CERTIFICATE OF APPROPRIATENESS

Property: 909 Travis Street, Lot 1, 2, 6, 7, 8, 9, 10, and 12 Tract 3a and 11a, Block 57, SS BB Subdivision. The property includes the Rice Lofts: A historic seventeen-story brick hotel converted into apartments with ground floor storefronts situated on a 31,250 square foot (125' x 250') lot along Texas Street between Travis and Main Streets.

Proposal: Alteration – Sign

SIGN DETAIL
FRONT VIEW

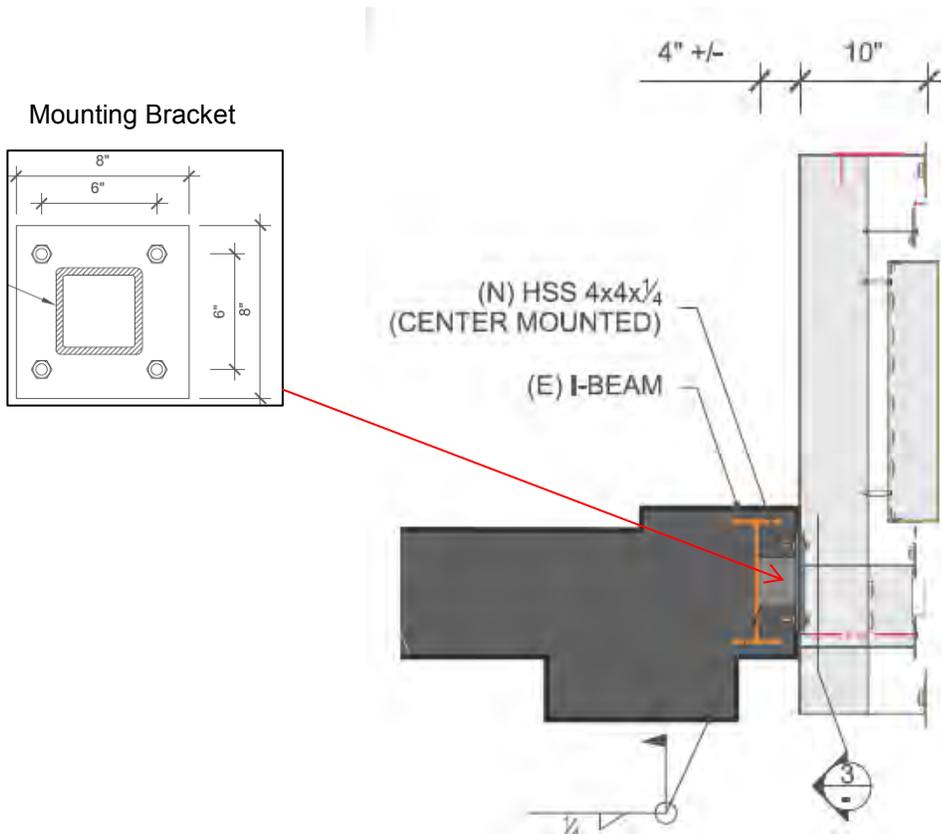
Shape/Mass: The applicant proposes to install a 7' 6" wide by 3' 9" tall sign along the secondary canopy above the second storefront bay from the rear of the building on the Travis Street side of the property. The sign will feature 2' 3" tall reverse lit channel letters spelling *Lawless* with push through lit 4" tall text spelling *Spirits & Kitchen*.

The sign will be mounted to the existing canopy by removing two 8" by 8" sections of the canopy cladding and mounting two square plates into the existing I-beam within the canopy.
